# UNITED STATES PATENT AND TRADEMARK OFFICE

## Office Action Summary

10/560,045

## **DETAILED ACTION**

Figure 1. Annotated view of Igra FIG. 1

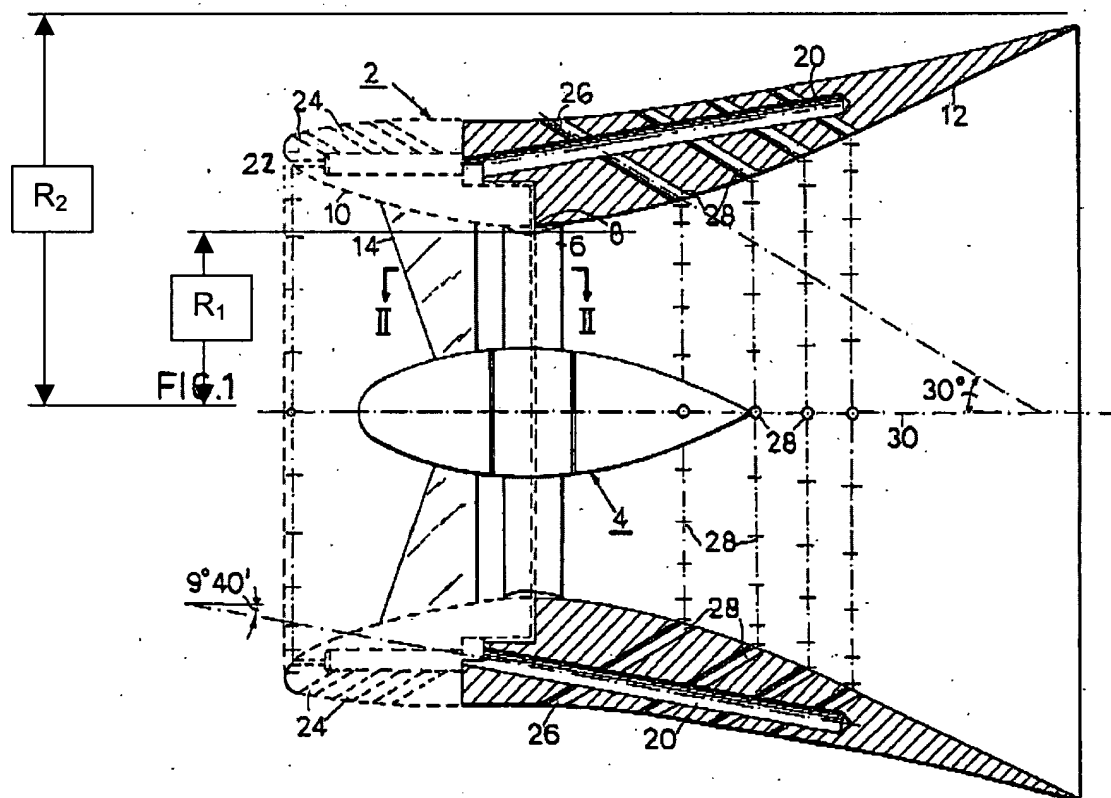
Igra show a wind power generator, comprising: an approximately cylindrical duct with the side cross-section thereof having a wing-like shape 2 (see FIG. 1);

a maximum wing thickness position is nearer a leading edge than a center of the chord in the side cross-sectional wing-like shape of the duct (see FIG. 1), an opening diameter of a front end of the duct made smaller than an opening diameter of a rear

end, and an outer diameter of the duct is made approximately uniform at least in a rear portion of the duct (see FIG. 1),

the pencil body 4 is installed such that a front end portion is positioned rearward from a front end portion of the duct and a rear end portion is positioned forward from a rear end portion of the duct (see FIG. 1), and

a ratio of maximum outer diameter of the duct with respect to a minimum inner diameter of the duct is within a range between 2.0 and 4.3 (see Figure 1 below).
